DART SERVICE INSTRUCTION

TO AMEND INSTALLATION INSTRUCTIONS IIN-D350-600 REV. C
INSTRUCTIONS FOR CONTINUED AIRWORTHINESS ICA-D350-600 REV. 4

REF. TCCA STC: SH93-88

SECTION 'L-L' UPPER HINGE ASSEMBLY

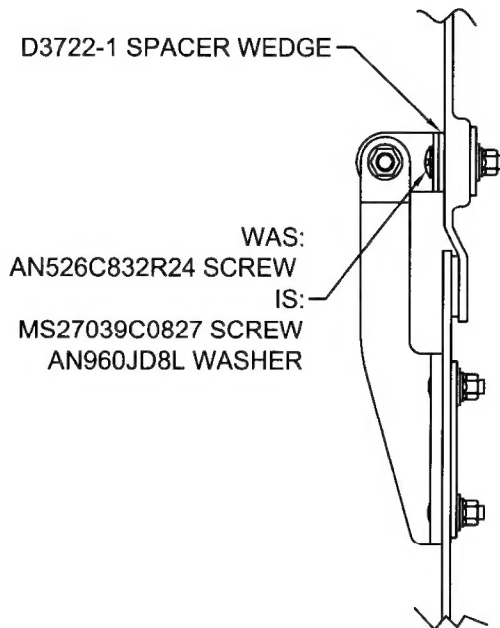
For the D355-600-243 Spacepod™ Kit at CHG 002 the AN526C832R24 screws that fasten the upper D3538-1 hinge to the Spacepod™ body have been replaced by MS27039C0827 screws with AN960JD8L washers. In addition, a D3722-1 spacer wedge was incorporated between the D3538-1 hinge and the Spacepod™ body. Figure 10 of ICA-D350-600 should be updated as shown below:
